UNITED STATES  
DEPARTMENT OF THE INTERIOR  
BUREAU OF LAND MANAGEMENT

FORM APPROVED  
OMB NO. 1004-0135  
Expires: July 31, 2010**SUNDRY NOTICES AND REPORTS ON WELLS**  
*Do not use this form for proposals to drill or to re-enter an abandoned well. Use form 3160-3 (APD) for such proposals.***SUBMIT IN TRIPLICATE - Other instructions on reverse side.**

COG Operating LLC, respectfully requests to recompleate to the San Andres.

Jenkins B Federal #9

Jenkins B Federal #9

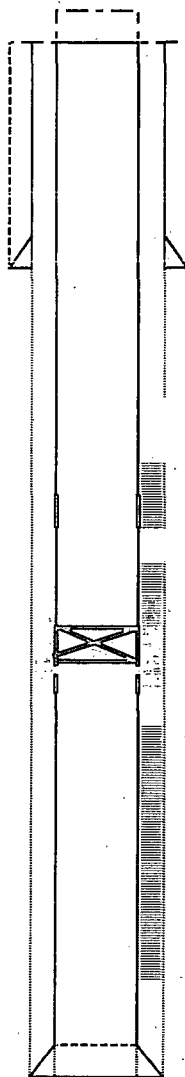
- 1. Operator shall set a CIBP at 4,246' and place 25sx Class C cement on top. Tag required at a minimum of 4,000' to seal the top of the Glorietta and DV tool.**

- 2. Must conduct a casing integrity test before perforating and fracturing. Submit results to BLM. The CIT is to be performed on the production casing to max treating pressure. Notify BLM if test fails.**
